Case Number **ZC-17-171**

**ZONING MAP CHANGE
STAFF REPORT**

Proposed Use: **Multifamily**

To: PD/D Planned Development for all uses in "D" High Density Multifamily with height up to 42 ft.; site plan included

City of Fort Worth
Title: PD SITE PLAN

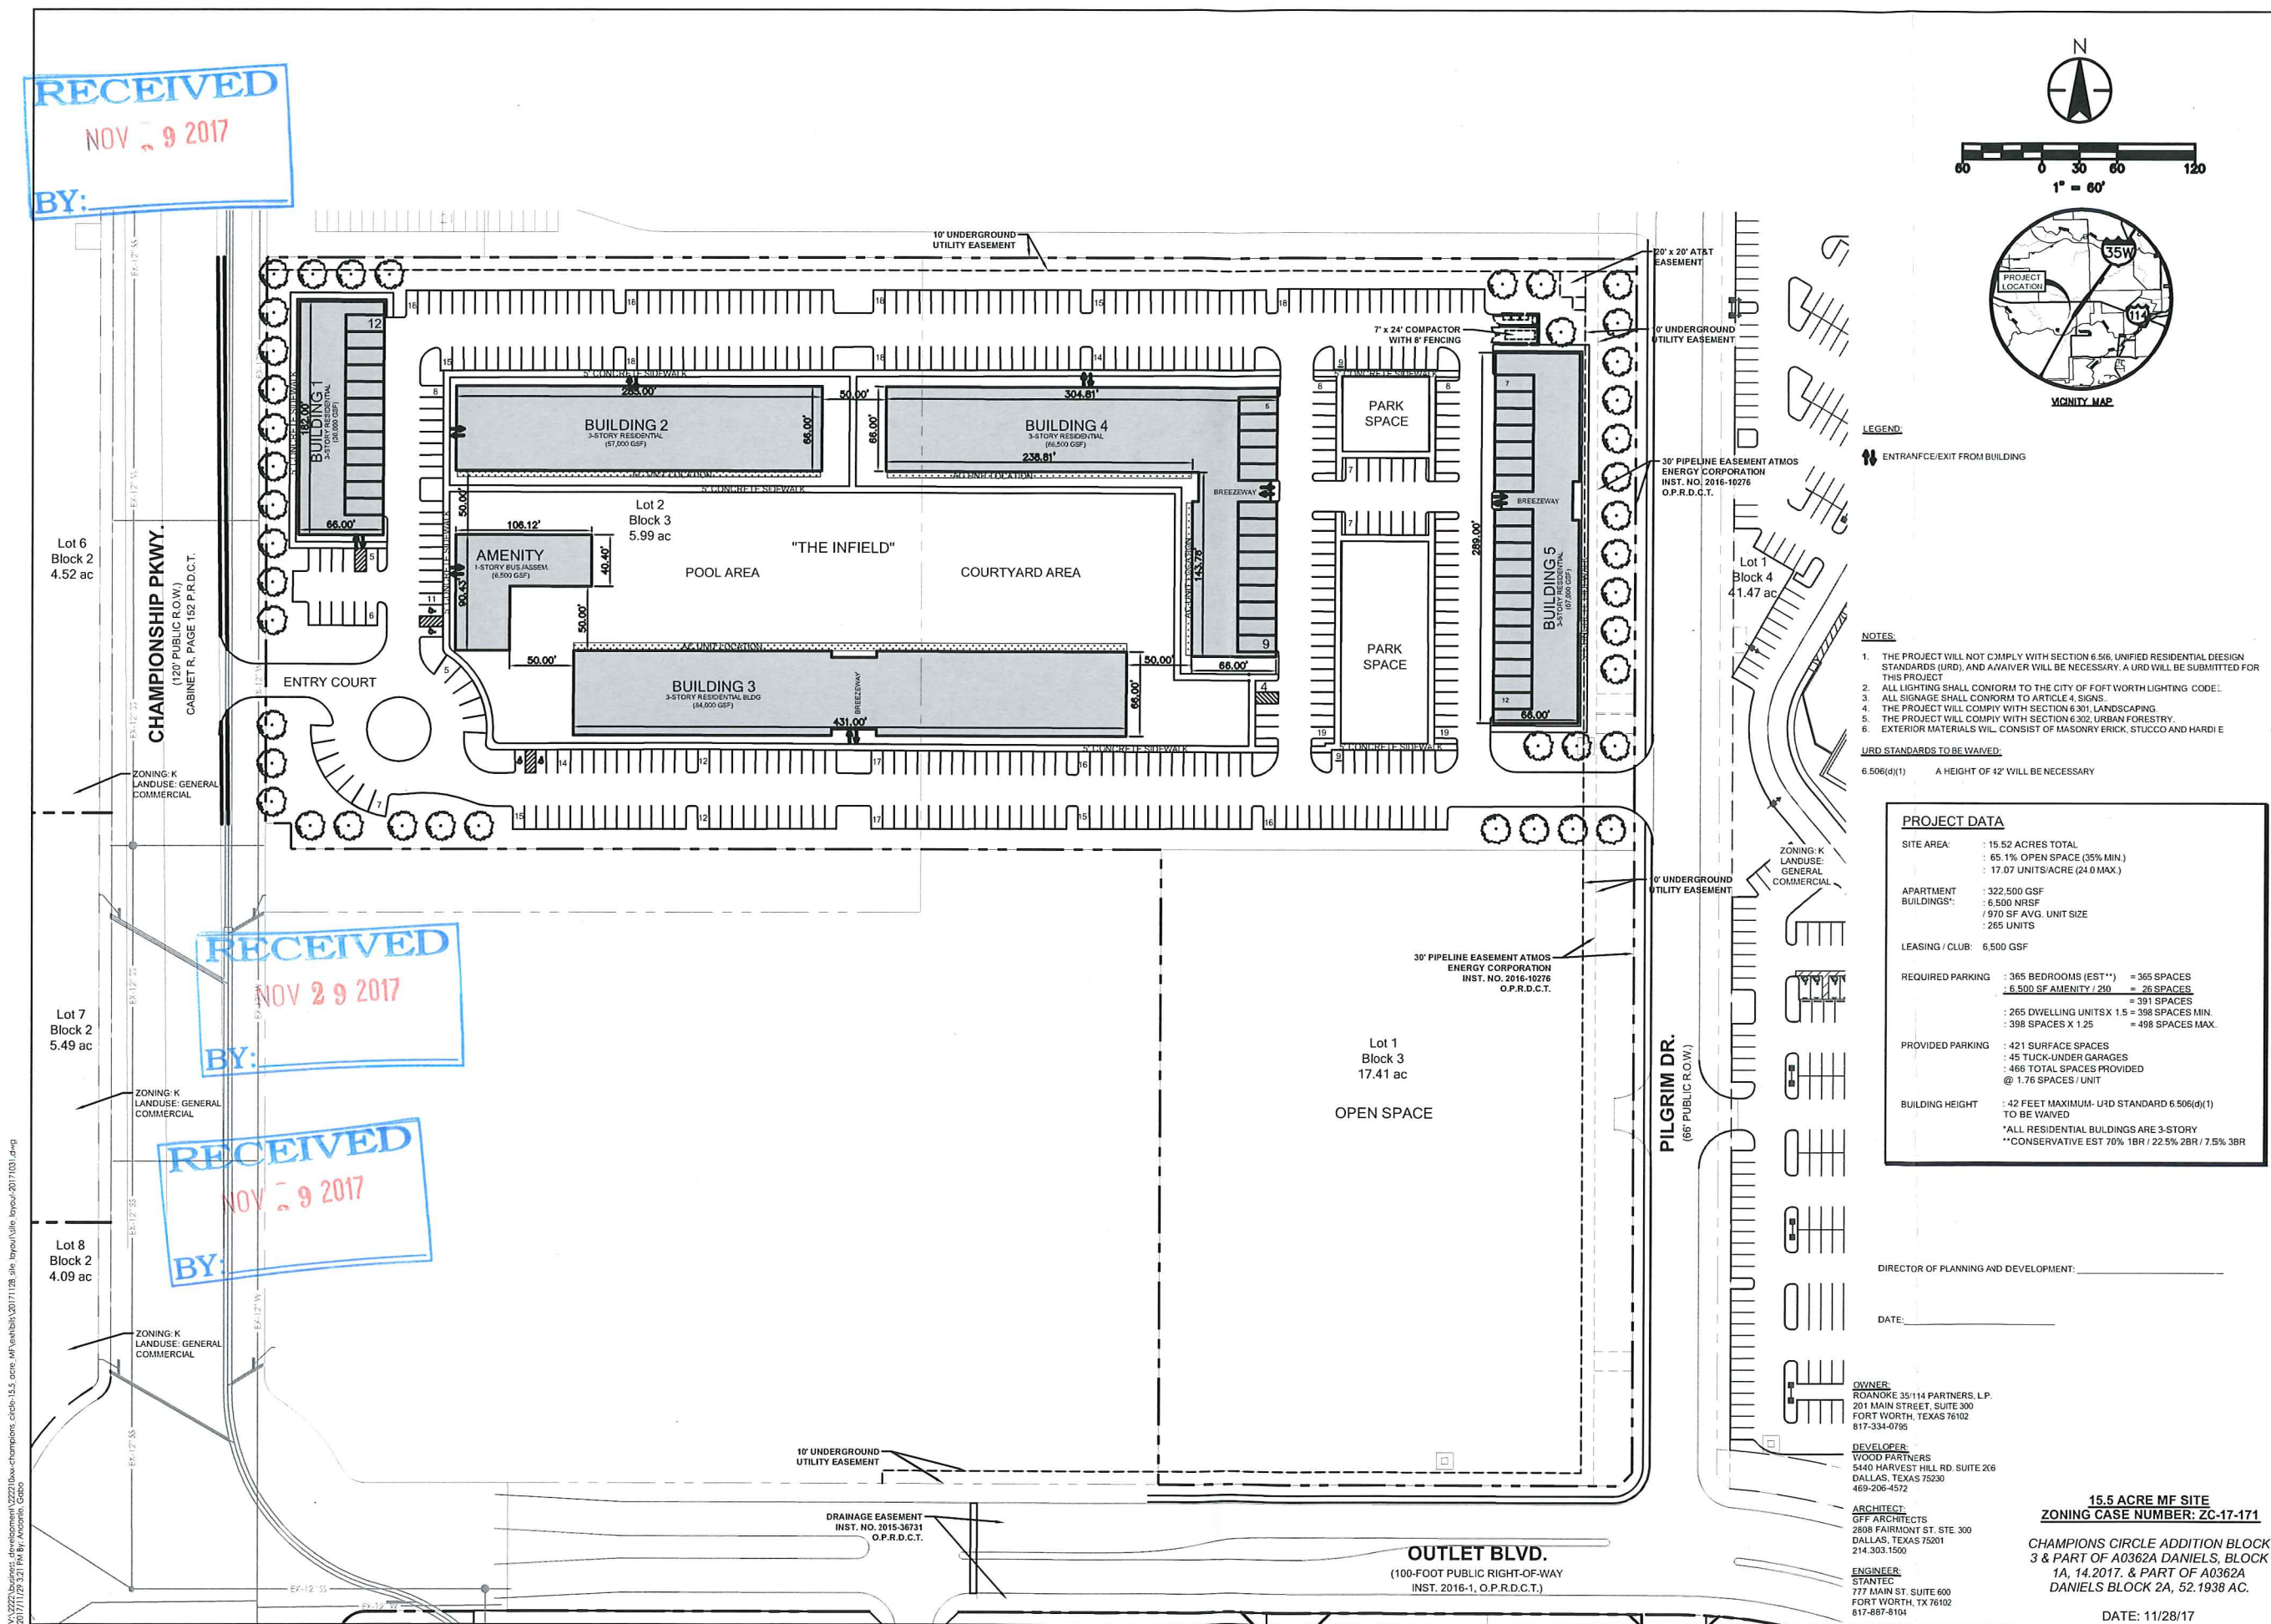
The site plan as submitted is not in general compliance with the Zoning Ordinance regulations. The key deficiencies are:

1. The maximum height for multifamily is 32 ft. Site plan indicates 42 ft. **(waiver required)**
2. The maximum parking spaces required is 498, site plan indicates 466 spaces. **(waiver required)**

1. A replat of Lot 2, Block 3 will be required. All remainders of Lot 2, will be included in that replat.
2. Since this apartment complex has more than 100 dwelling units, two points of ingress and egress must be provided with gated entrances meeting TPW design standards for gated entrances with adequate stacking and turnarounds.
3. All named emergency access easements must be shown on the plat.

1. Secondary Ingress and Egress (Ch. 31-101.c) – Subdivisions containing more than thirty (30) one-family or two-family dwelling units shall have a platted and constructed secondary ingress and egress to a public street. Multi-family developments of 100 dwelling units or more shall have a platted and constructed secondary ingress and egress to a public street.

2. Emergency Access Easements (Ch.31-104.C) - Emergency access easements shall not be less than 26' in width. Show the full 26' width on the plat. Where emergency access easements intersect, the dedication of a 10' by 10' public open space easement (POSE) shall be dedicated for sight visibility shall be required. The emergency access easements shall remain unobstructed at all times. A 26 ft. for multi-family development with densities exceeding 100 units (must have access to one public street in addition to public access easement)

3. Gated Entrances (Ch. 31-107) - Gated entrances into secured areas must be designed in accordance with TPW's "Traffic Engineering Design Standards and Policy Guidelines". Provisions for an acceptable turnaround must be made. Provide details in IPRC plan set (single-family) or UR site plan (multi-family)

for gates. All gates shall be equipped with a knox-box or other approved fire access apparatus that is reviewed and approved by the Fire Department. (Gates must be located 3 vehicle lengths from the ROW)
4. Sidewalks (Ch. 31-106-C-15) - Sidewalks and street lights are required for all public and private streets and public access easements as per City of Fort Worth Standards

Zoning Commission recommended waivers to the items noted above.
